# PLANNING COMMISSION

**December 13, 2023 at 7:00 PM**

Members of the Planning Commission  
**STAFF REPORT**  
For the Meeting of December 13, 2023

Major Variance & Subdivision, Upland Meadows Subdivision - MonteVista Homes 4N2802A Tax Lot 500 - 811 E Theater Ave

UPLAND MEADOWS  
 TENTATIVE PLAT  
 OVERVIEW

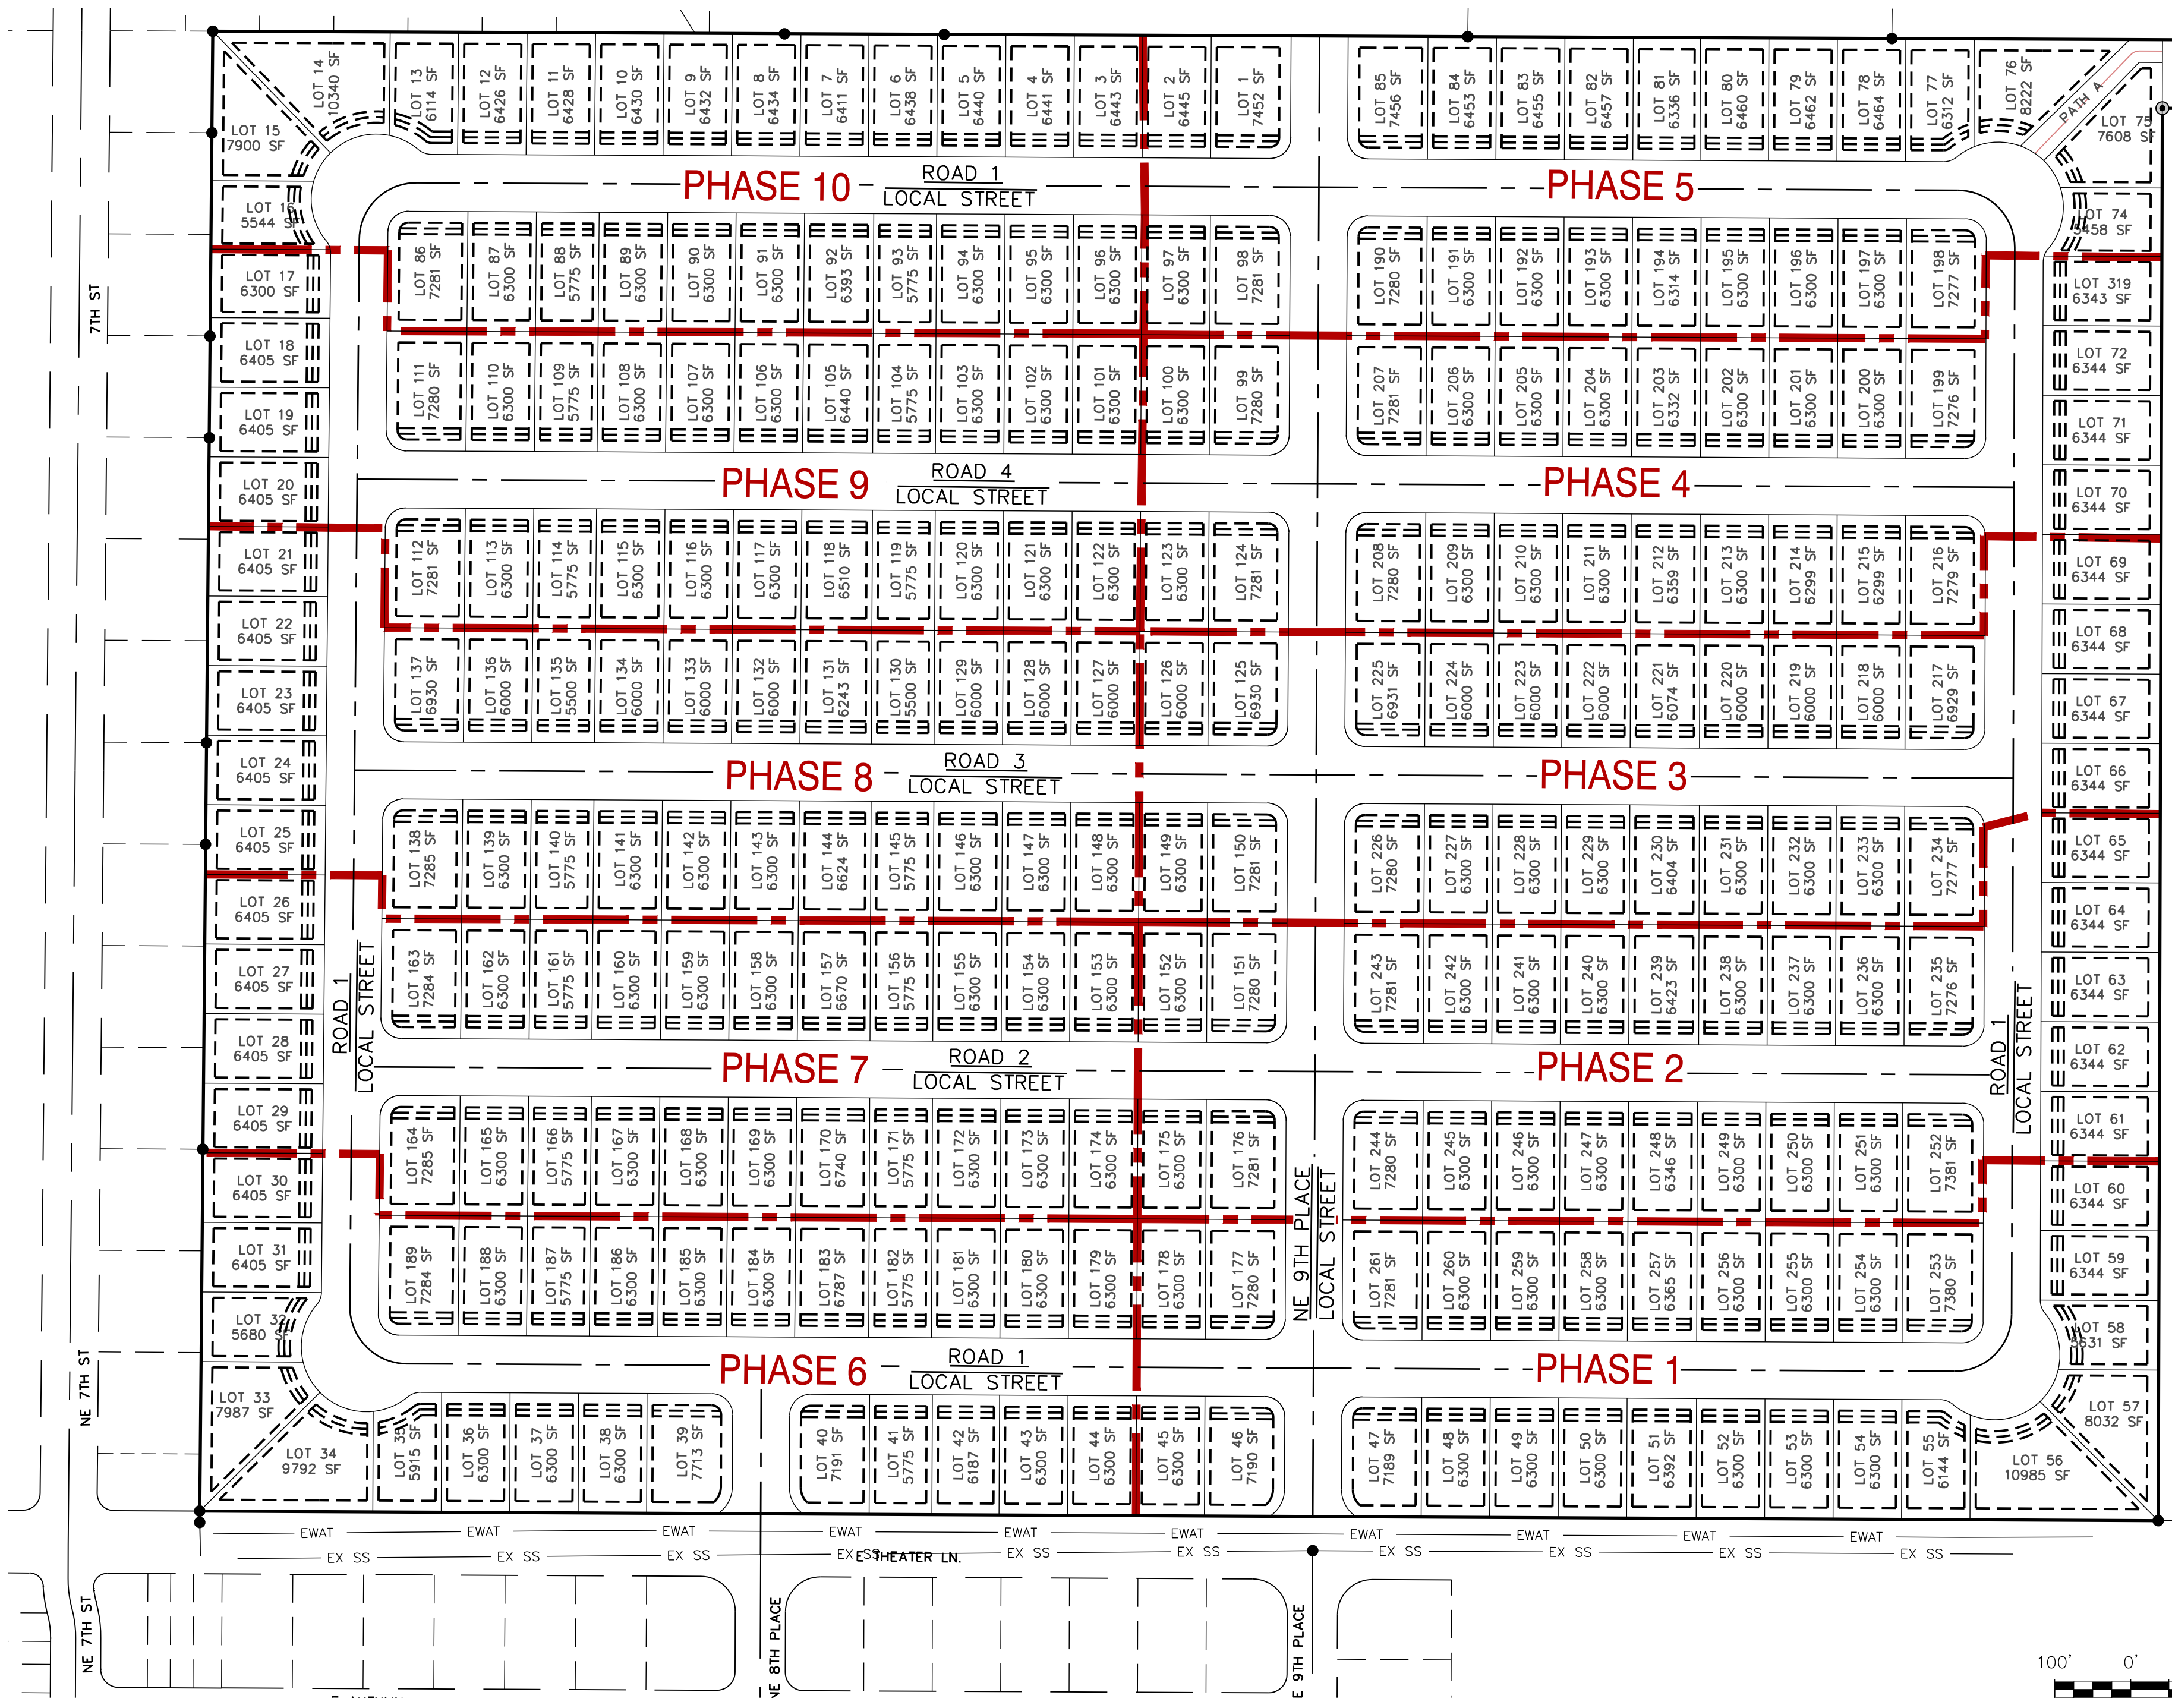
The variance request is necessary for the consideration of the preliminary plat as presented. Under city zoning rules, R-3 lots require a minimum lot width of 60 feet. Since 19 of the lots are between 55 and 58 feet in width, the plat does not meet zoning requirements unless a variance is granted by the planning commission. Therefore, if the planning commission does not grant a variance, the preliminary plat will require redesign. However, the planning commission may request a modification of the preliminary plat to be presented at the next meeting should the variance fail.

In requesting lot width deviations, the applicant is requesting to reduce the lot width from to between 58 and 55 feet for 19 lots. The application narrative makes the argument that the overall dimensions of the development site and road requirements make it necessary to reduce lot widths for four lots in each block in order to accommodate the increased lot width for corner lots (70 feet instead of 60 feet for internal lots) and the city's 50 foot right of way standard. The applicant has developed house plans intended to maximize the off-street parking and develop an optimal house on a 55-foot lot. The requested variance is intended to maximize the lot count within the development while also maintaining buildable lots by reducing the lot widths a minimal amount of 10% which would typically be an administrative variance at the staff level.

It is incumbent upon the planning commission to consider if the alternative proposed is acceptable, if mid-block paths will be required, or if block lengths exceeding 600 feet are not acceptable and an additional north/south street is required. Creation of an additional north/south street will require the loss of at least eight lots from the development.

Staff recommends that the planning commission condition the developer to develop street names in conformance with §94.22. Specifically, Roads 2, 3, and 4 are streets running east/west and shall all be designated as Avenues. The NE 9<sup>th</sup> Place extension is properly designated on the preliminary plat and shall retain that designation. Road 1 forms a complete loop around the development and shall be designated as a Drive. A short section of road is in alignment with NE 8<sup>th</sup> Place and shall be designated as NE 8<sup>th</sup> Place.

Staff recommends that the planning commission tentatively approve the two variance and preliminary plat but require the applicant to submit more detailed findings of fact for consideration at the January meeting. Following adoption of the findings of fact, the planning commission will make a final decision on the variances and preliminary plat and begin the standard appeal period.
